RE: 4540 72 Avenue NE, Canoe

APPENDIX A

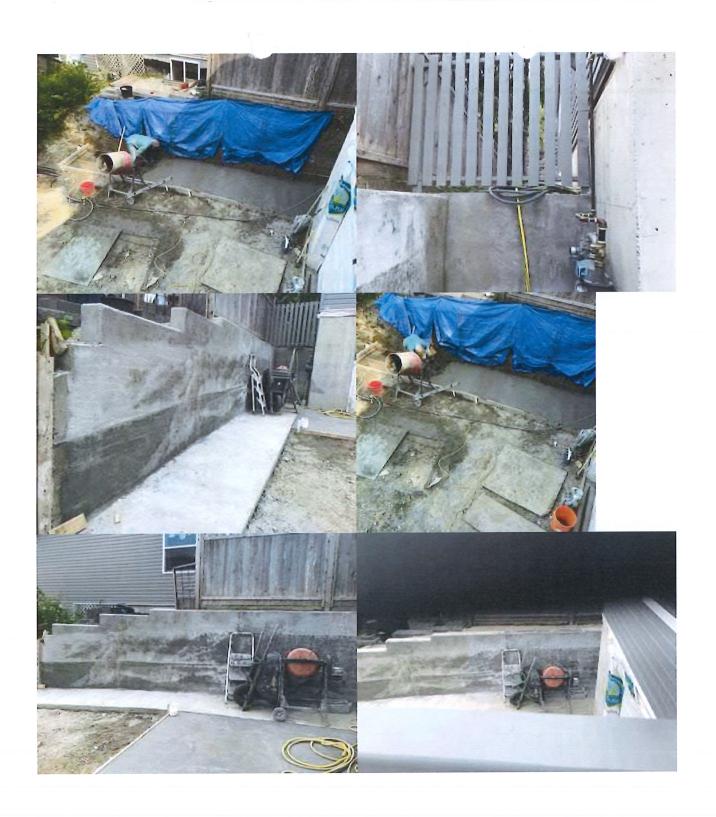
We were not called for field reviews. This also doesn't even meet frost requirements. Furthermore, your photos show that the concrete was mixed on site which is unacceptable unless third party testing was carried out. I chatted with Earle a few months back about reconfiguring the retaining wall footing to be more L-shaped. The conversation was left at Earle would be providing more accurate elevations so we could update a detail. It seems that things proceeded without our guidance or recommendations being followed. I can't sign off on this wall.
